# **Aligning Test 3 And Test 4 Fitted Insertion Loss Coefficients To Posted Channels (Comment # 146)**

Richard Mellitz  
Intel Corporation  
March 2015

# 3 Meter Cable Data (arrows are near COM limit)

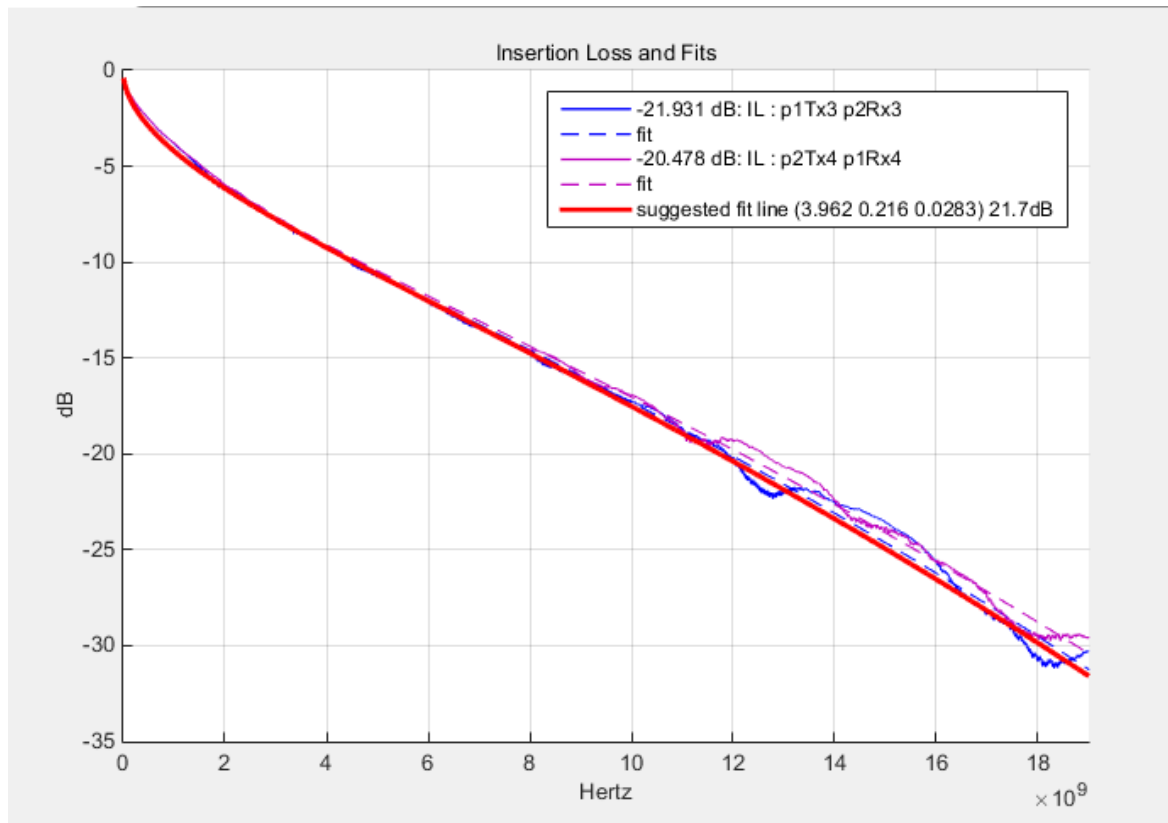
Worst coefficients chosen

Amphenol 3m								Tyco 3m							
	p1Tx1 p2Rx1	p1Tx2 p2Rx2	p1Tx3 p2Rx3	p1Tx4 p2Rx4	p2Tx1 p1Rx1	p2Tx2 p1Rx2	p2Tx3 p1Rx3	p2Tx4 p1Rx4	1_victi m_P1/P 2	2_victi m_P1/P 2	3_victi m_P1/P 2	4_victi m_P1/P 2	5_victi m_P2/P 1	6_victi m_P2/P 1	7_victi m_P2/P 1	8_victi m_P2/P 1
a1	4.07	4.09	3.92	3.36	3.46	3.69	3.53	3.96	3.40	3.93	3.43	3.85	4.02	3.81	4.02	3.78
a2	0.17	0.14	0.22	0.57	0.47	0.39	0.39	0.18	0.52	0.24	0.50	0.24	0.15	0.25	0.15	0.28
a4	0.03	0.03	0.03	0.01	0.02	0.02	0.02	0.03	0.01	0.02	0.01	0.02	0.03	0.02	0.03	0.02
IL as Rx Test Cable	21.89	21.43	21.56	21.88	21.20	21.41	21.05	21.04	20.54	20.98	20.45	20.93	20.51	20.16	20.66	20.39
IL cable assembly	15.32	15.77	15.02	16.21	14.93	14.63	13.96	14.16	14.62	14.35	14.34	14.14	13.80	13.94	13.90	13.90
COM	2.90	3.38	3.10	2.67	2.89	3.21	2.93	3.09	3.68	3.52	3.58	3.68	3.28	3.33	3.19	3.40

# 3 meter FEC Test Fit Line Graphs

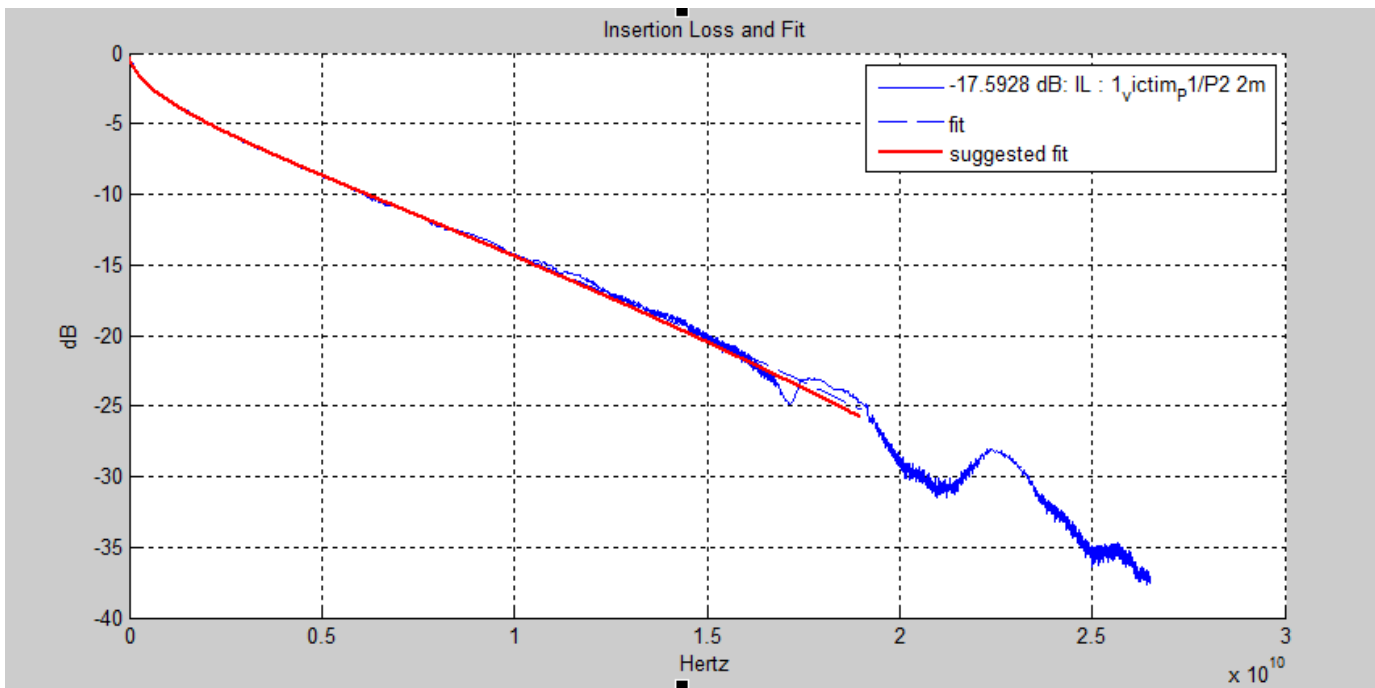
# 2 meter CL74 no FEC Test Fit Line Graphs

a1=3.96	a1=3.00
a2=0.18	a2=0.29
a4=0.03	a4=0.02

approximate fit loss at 12.89GHz	14.80	29.44	21.04	17.57	dB
----------------------------------	-------	-------	-------	-------	----
